Economic Commission for Europe**Inland Transport Committee****Working Party on the Transport of Perishable Foodstuffs****Seventy-fourth session**

Proposals of amendments to ATP:**New proposals**

Proposal to amend ATP by introducing special provisions applicable to packages and vehicles and containers containing substances presenting a risk of asphyxiation when used for cooling or conditioning purposes (such as dry ice (UN 1845) or nitrogen, refrigerated liquid (UN 1977) or argon, refrigerated liquid (UN 1951))

Transmitted by the Government of Switzerland

Figure 2.6.2

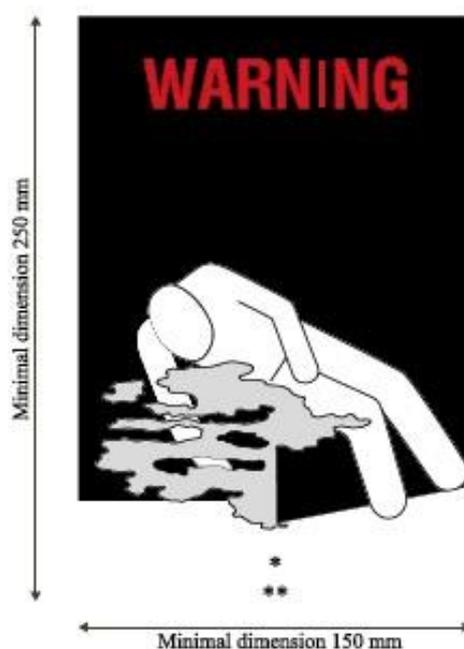
2.6.2 The warning mark shall be as shown in Figure 2.6.2.

* Insert the name indicated in Column (2) of Table A of Chapter 3.2 of ADR/ADN/RID of the coolant/conditioner. The lettering shall be in capitals, all be on one line and shall be at least 25 mm high. If the length of the proper shipping name is too long to fit in the space provided, the lettering may be reduced to the maximum size possible to fit. For example: "CARBON DIOXIDE, SOLID".

** Insert "AS COOLANT" or "AS CONDITIONER" as appropriate. The lettering shall be in capitals, all be on one line and be at least 25 mm high.

The mark shall be a rectangle. The minimum dimensions shall be 150 mm wide x 250 mm high. The word "WARNING" shall be in red or white and be at least 25 mm high. Where dimensions are not specified, all features shall be in approximate proportion to those shown.

The word "WARNING" and the words "AS COOLANT" or "AS CONDITIONER", as appropriate, shall be in an official language of the country of origin and also, if that language is not English, French or German, in English, French or German,
